NMP2L2731

U.S. Nuclear Regulatory Commission
ATTN: Document Control Desk
Washington, DC 20555-0001Nine Mile Point Nuclear Station, Unit 2
Renewed Facility Operating License No. NPF-69
NRC Docket No. 50-410

Subject: Response to Request for Additional Information by the Office of Nuclear Reactor Regulation to Support Review of Nine Mile Point Nuclear Station, Unit 2, License Amendment Request to Increase Allowable MSIV Leakage Rates

RESPONSE TO REQUEST FOR ADDITIONAL INFORMATION

Figure RAI-5a: Time-Dependent Aerosol Particle Size Distribution

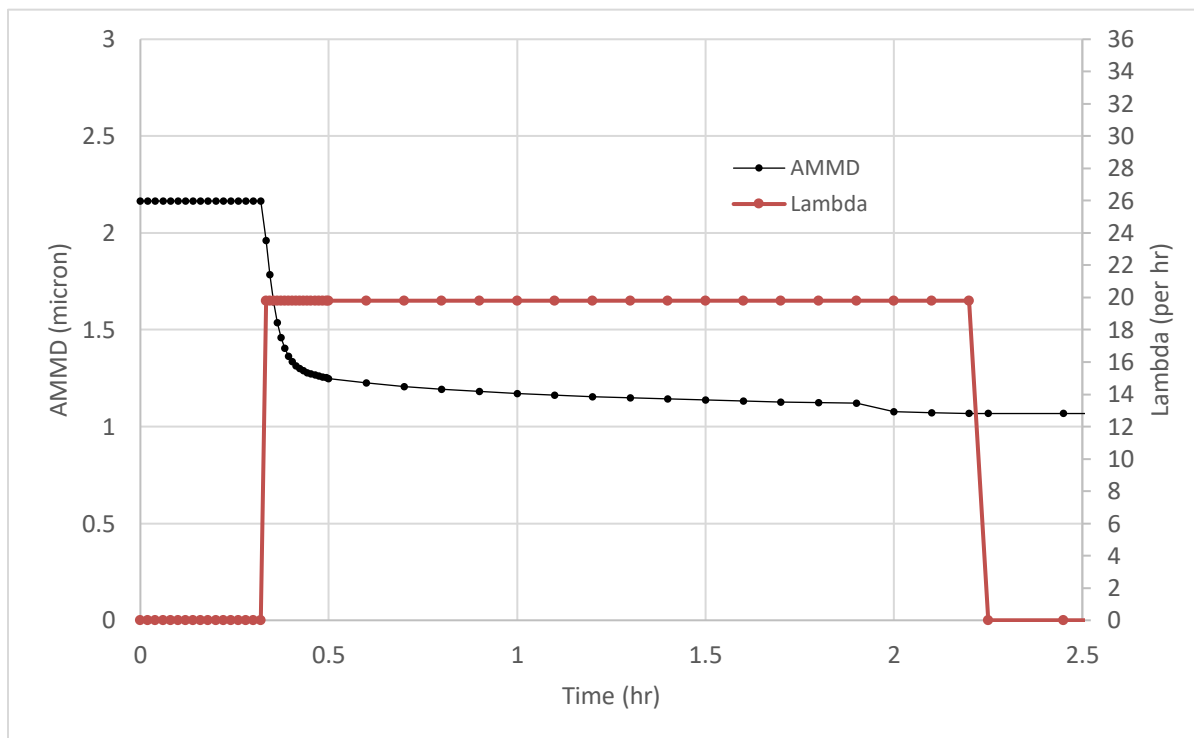
Please provide technical information to:

Exelon Response to RAI 5

The Nine Mile Point 2 current licensing basis (CLB) includes several specific conservatisms included in the LOCA dose consequence assessment that were credited as part of the approval of the Alternate Source Term (AST) amendment, whose design basis was provided by H21C-106, Revision 2. Regulatory Guide (RG) 1.183, "Alternative Radiological Source Terms for Evaluating Design Basis Accidents at Nuclear Power Plants" defines AST as a fission product release from the reactor core into the containment (more specifically in the drywell for BWRs). As indicated in Appendix A to RG 1.183, Regulatory Position 6.1, the NRC accepts the

Both the CLB and the revised LOCA AST dose analysis assume the drywell is the source of MSIV leakage in accordance with the NRC guidance summarized above, so it is appropriate to consider radionuclide removal mechanisms in the drywell before release via the MSIV leakage pathway. A sensitivity analysis was performed to evaluate the impact of sprays on the aerosol settling velocity and to identify other inputs with well-defined uncertainty or conservatism that could be used to offset the uncertainty associated with the current aerosol deposition model. This sensitivity analysis concludes that conservatism associated with modelling the total MSIV leakage as split between two lines as opposed to split evenly among all four (4) lines with an assumed break in an MSL (to address RAI-4 above) approximately offsets the uncertainty introduced by the drywell spray effects on the aerosol deposition model. Other conservatisms explicitly evaluated in the sensitivity analysis are discussed below.

A simplified model was developed using first principles as identified in NUREG/CR-5966, "A Simplified Model of Aerosol Removal by Containment Sprays." Specifically, the ordinary differential equation shown on page 1 of NUREG/CR-5966 was solved to provide an analytical solution of the suspended aerosol mass in the drywell. The spray removal rate in this simplified model is the same as that identified in H21C-106 Section 2.1.3.2 and RG 1.183, Appendix A, Section 3.3. Since sprays will remove aerosols at different rates depending on their particle size, the spray removal rate is adjusted by collection efficiency variation as provided in Figure 19 of NUREG/CR-5966. The suspended aerosol mass was solved from the beginning of the accident through the termination of the removal of aerosols by drywell sprays at 2.25 hours for 20 distinct particle size groups. The mass of particles in each group is defined by the probability distribution associated with the source distribution.

A total of seven sensitivity cases were performed by varying the base case. The base case is essentially the H21C-106, Revision 4 model including the MSL nodalization, MSL break of the "A" inboard line, and flow rate distribution adjustments described in Attachment 13.19 (to address RAI-4 above), as well as the revised aerosol removal factors described above. As Table RAI-5e indicates, the seven sensitivity cases are various combinations of the three sensitivities described above (breathing rate, MSIV impaction, and condenser holdup). The sensitivity case results are summarized in Table RAI-5e.

As expected, the base case indicates the conservative modelling of the drywell spray impact on the aerosol removal in the main steam lines without adjusting any other inherent conservatisms in the RADTRAD inputs results in increased doses. Because the MSIV leakage portion of the Control Room dose is only 0.40 rem in the base analysis (H21C-106, Revision 4, Attachment 13.19), the increase (~0.26 rem) due to the revised aerosol removal rates does not increase the Control Room dose above the 5 rem limit. Rather, as the results in Table RAI-5e indicate, the base case doses are within approximately 2% of the previously submitted results (shown as H21C-106 Main Body).

The dose increase due to the revised aerosol removal rates is offset by modelling all four main steam lines with 50 scfh of leakage each compared to only two main steam lines with 100 scfh of leakage each as in the main body of H21C-106, Revision 4. The revised main steam line nodalization and flow distribution is enough to offset the offsite dose increases due to the revised aerosol removal rates without crediting any additional margin. The combined effects of the nodalization changes and breathing rate reduction or impaction offset the Control Room dose increase. Crediting the condenser reduces the MSIV leakage contribution to the Control Room dose to approximately 1% of the total dose.
